UNITED STATES PATENT AND TRADEMARK OFFICE

APPLICATION NO.	FILING DATE	FIRST NAMED INVENTOR	ATTORNEY DOCKET NO.	CONFIRMATION NO.
10/023,284	12/15/2001	Donald P. Kenney	11109-00006	7592
27160	7590	12/19/2005	EXAMINER	
KATTEN MUCHIN ROSENMAN LLP 525 WEST MONROE STREET CHICAGO, IL 60661-3693			KOCZO JR, MICHAEL	
			ART UNIT	PAPER NUMBER
			3746	
DATE MAILED: 12/19/2005

Office Action Summary

DETAILED ACTION

Fig. 3.

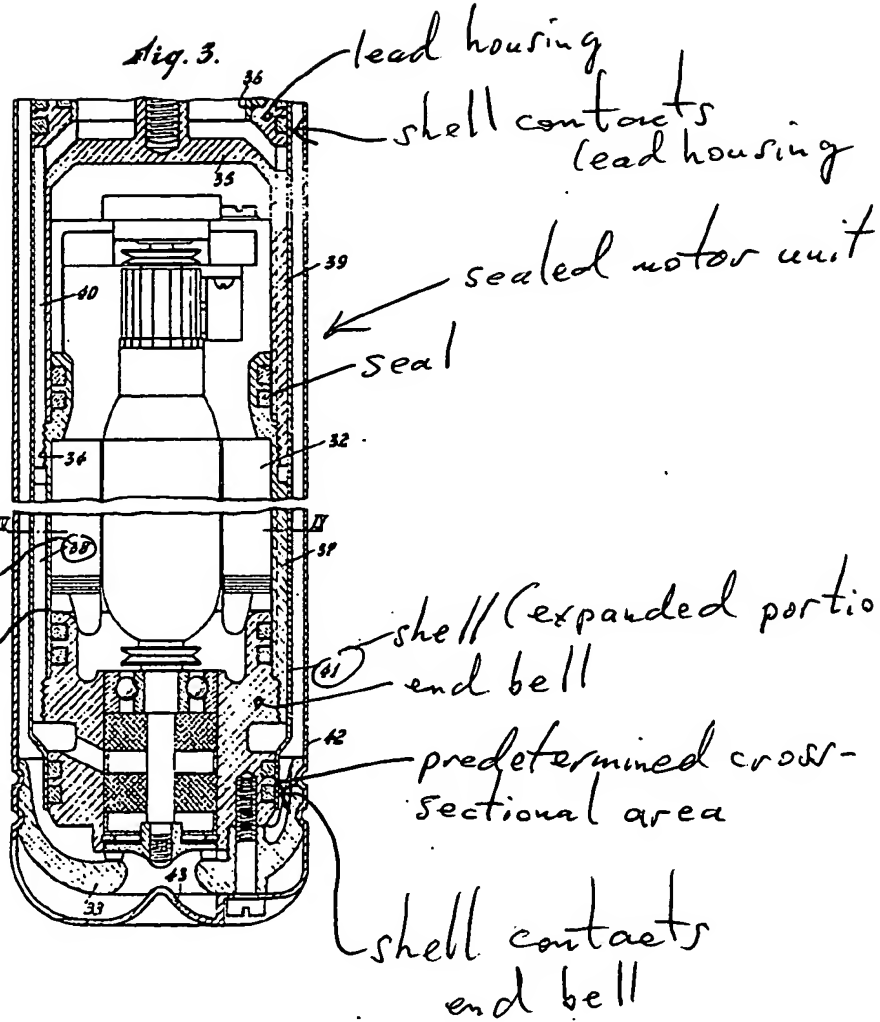
Claims 2, 3, 4, 5, 9, 11, 15, 22 and 23 are rejected under 35 U.S.C. 102(b) as being anticipated by Avigdor (CH 207,150). See attachment "A" which shows figure 3 with the claimed structure identified. Figure 3 shows a sealed motor unit having a motor housing, a pump assembly having a predetermined cross-sectional area, and a shell 41 having an expanded portion that is relatively larger than the predetermined cross-sectional area. A cavity 38 is formed between the shell 41 and the motor housing. The shell contacts the end bell and the lead housing. The shell 41 inherently aligns the pump assembly components to the motor unit since it is connected to both. See figure 5 which shows the pump 69 submerged in a tank 67 and connected to a manifold which leads to dispensers 74. Regarding claim 23, the flow rate of an electric motor driven pump is inherently capped (limited) by its design.

lead housing
shell contacts
lead housing
sealed motor unit
seal
shell (expanded portion)
end bell
predetermined cross-sectional area
shell contacts
end bell
